Product Change Notification

Change Notification #: 115472 - 00

**Change Title: Intel® Wireless Gigabit 11000
PCN 115472-00, Label,
Label Change**

Date of Publication: April 21, 2017

PRODUCT CODE	CURRENT LABEL	NEW LABEL
11000.D2WG.RF

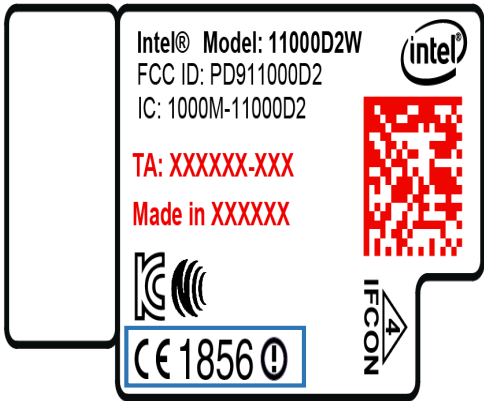
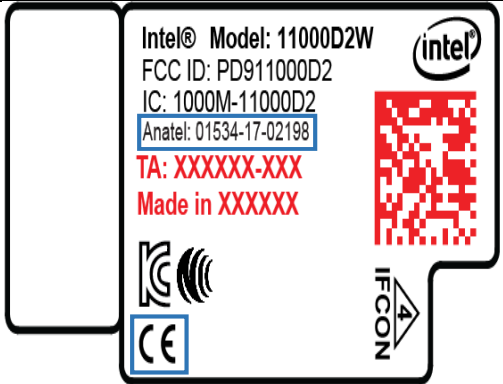
1. The current CE ! Mark on the module will be modified to remove the Alert Symbol (!) and the number 1856 following the CE mark.
2. Addition of the Brazil Regulatory ID as indicated below to the module label.
Anatel ID: 01534-17-02198
